Model 225H

Support

SERVICE 		11
		97-10-08

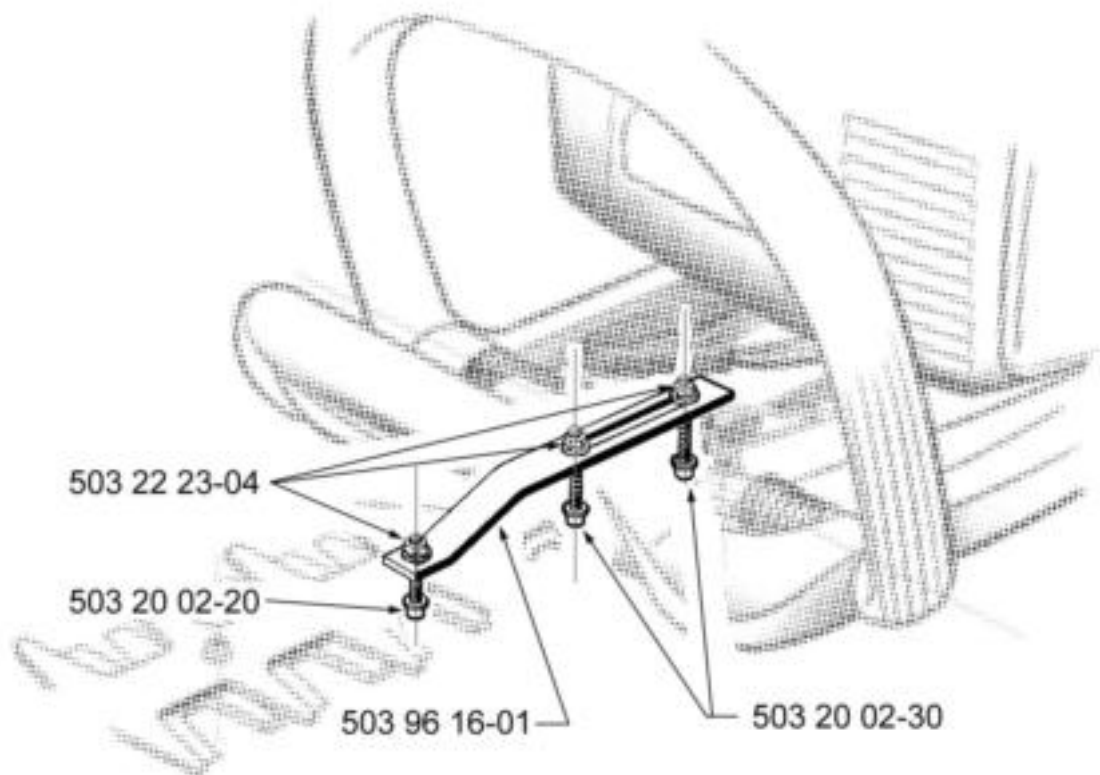
A new part has been developed to improve the stability of the cutting unit. This is held in place by three bolts, which are secured with 3 self-locking nuts. Below is a list of the parts needed for the rework. These parts fit hedge trimmers with a cutting length of 60 cm or 75 cm. To prevent vibration being transferred from the engine to the handles a 15 mm diameter hole should be drilled as shown on page 2. It is also possible to mark the centre of the hole by inserting a sharp tool through the front bolt hole on the gear housing.
